# UNITED STATES PATENT AND TRADEMARK OFFICE

APPLICATION NO.	FILING DATE	FIRST NAMED INVENTOR	ATTORNEY DOCKET NO.	CONFIRMATION NO.
10/734,014	12/11/2003	John G. Nunan	034166.053	2369
25461 7590 04/11/2008 SMITH, GAMBRELL & RUSSELL SUITE 3100, PROMENADE II 1230 PEACHTREE STREET, N.E. ATLANTA, GA 30309-3592				
EXAMINER				
MERKLING, MATTHEW J				
ART UNIT		PAPER NUMBER		
1795				
MAIL DATE		DELIVERY MODE		
04/11/2008		PAPER

### Office Action Summary

**DETAILED ACTION**

Figure 5: Alloying between Pd and Rh has a large detrimental impact on high temperature NO $_x$  performance.

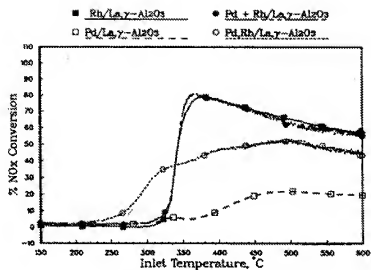
or the specification that the prior art (Nunan) would not also contain this property. In fact, Nunan discloses a preference for operating the co-impregnated Pd/Rh catalyst in a non-alloyed state. For example, see Figs. 5 and 7 which are comparisons of alloyed and non-alloyed Pd/Rh catalysts. It can clearly be seen that a non-alloyed Pd/Rh catalyst (as shown in Fig. 7) better exhibits the NO<sub>x</sub> reduction property of Rh than does the alloyed Pd/Rh catalyst shown in Fig. 5.

As best understood, Applicant is arguing that the Nunan prior art only teaches and suggests an alloyed (between Pd and Rh) catalyst. The examiner respectfully disagrees with this argument. Throughout the Nunan reference, it is explicitly disclosed that a non-alloyed catalyst (which is co-impregnated, meaning it is in the same catalyst layer) is preferable over an alloyed catalyst. For example, in Fig. 5, Nunan shows the performance of a catalyst that contains an alloyed catalyst:

As can also be seen in the caption, Nunan explicitly states the detrimental effects of alloying a Pd/Rh catalyst.

Figure 7: The light-off performance for NO<sub>x</sub> over the Pd-Rh catalyst looks more Rh-like after the high temperature lean conditioning.

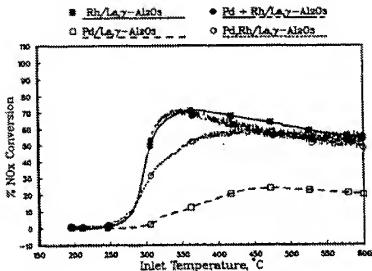
Furthermore, Nunan also discloses a Figure which indicates the catalyst performance when the Pd/Rh catalyst are non-alloyed:

As shown by comparing these two graphs, after the high temperature lean conditioning of the Pd/Rh catalyst (which "de-alloys" the Pd/Rh catalyst, see Nunan, page 4, col. 2, final paragraph - page 5, col. 1 first paragraph).

As such, Nunan explicitly discloses an example where a single layer Pd/Rh catalyst is non-alloyed, and further suggests the preference for de-alloying the Pd/Rh catalyst.
